STANNAH LIFTS LTD, SAFETY BULLETIN

Re: HYDRAULIC PASSENGER LIFTS WITH 2:1 ROPING

Stannah Lifts Safety Bulletin

Issue No: M31(a)

Fig 1
Replacement required

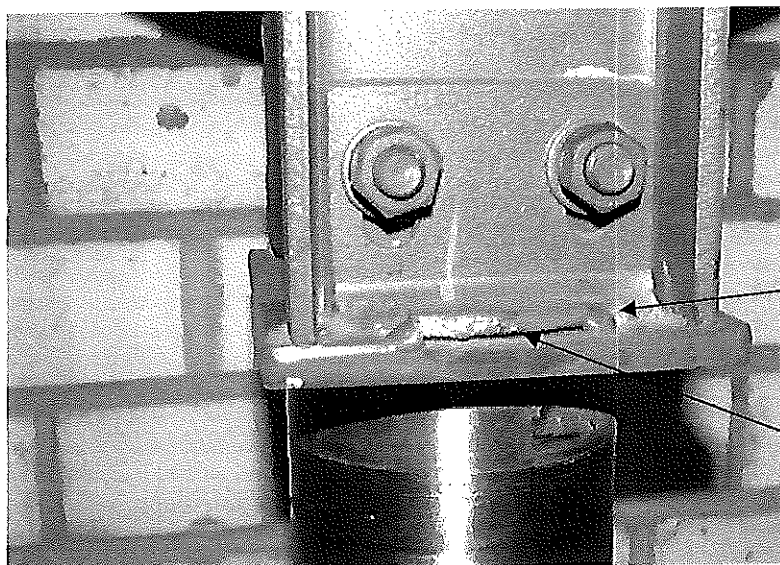
Stannah Lifts Ltd have experienced a problem with a welded steel bracket which failed due to welds breaking on one 18 year old lift, resulting in the safety gear engaging.

The welded bracket is fitted at the base of the tackle pulley assembly which supports the main suspension ropes and secures the top of the piston to the tackle pulley assembly (*see Fig 1 below*). It consists of a 10mm thick flat baseplate, to which are welded two notched angle brackets (approx 6mm thick).

Investigations indicate that this design of bracket was supplied on tackle pulleys between approx. 1986 and 1991. Evidence also suggests that the bracket which led to the incident was only partially welded and should have been fully welded as shown in Fig 2.

Welded in notched corners of angle bracket only

No weld along this edge

To date only one incident has been reported. However, as a precautionary measure, it is recommended that all tackle pulley assemblies are inspected for any signs of deterioration and any found to incorporate brackets identical to that shown in Fig 1 above should be replaced with a different design.

It is strongly recommended that no full load rupture valve tests be undertaken (as required on LG1 test) on any brackets found to be to Fig 1 above.

Fig 2
Replacement not required

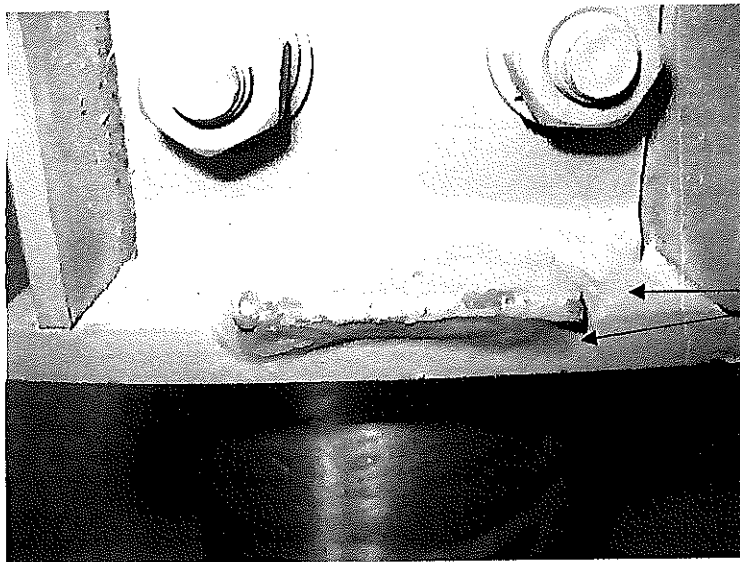
Bracket as Fig 1
but fully welded -
in notched corners
+ along edge of
bracket.

Welded brackets of the types shown in Figs 2, 3 and 4 below do not require replacement.

Fig 3
Replacement not required

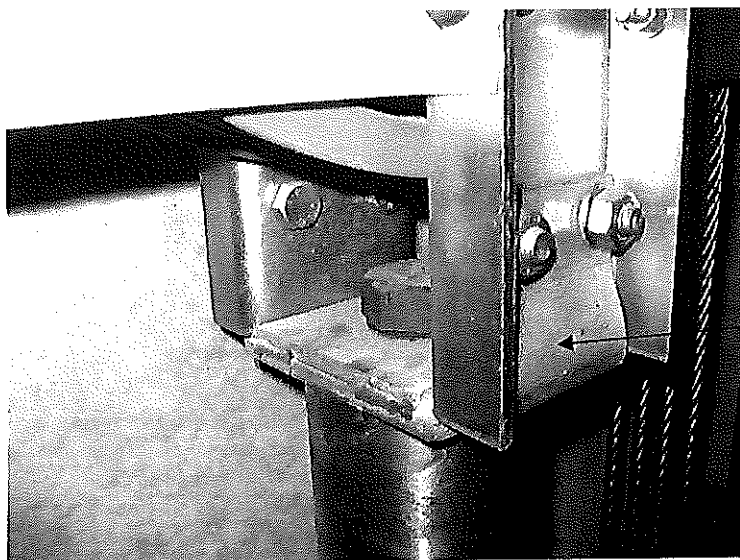
Folded profile with
plate welded
inside.

Fig 4
Replacement not
required

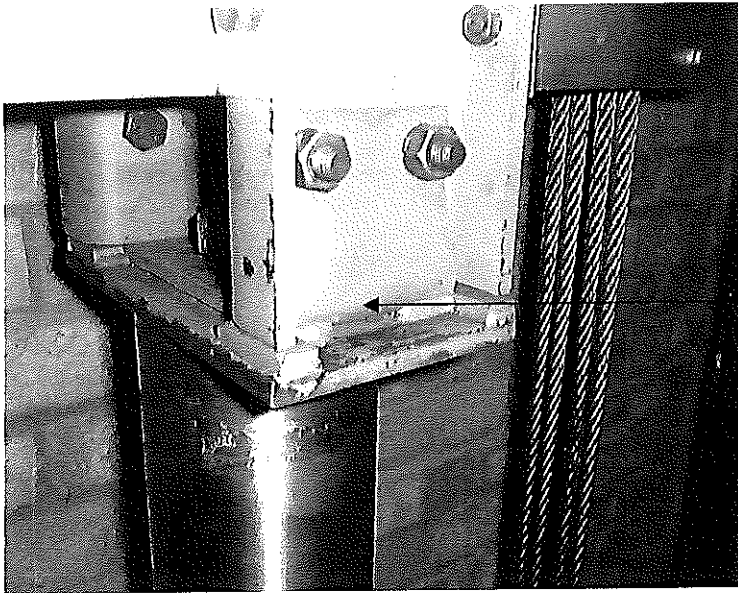
Bracket as Fig 3 but
with plate welded
underneath
incorporating 4 corner
spacers
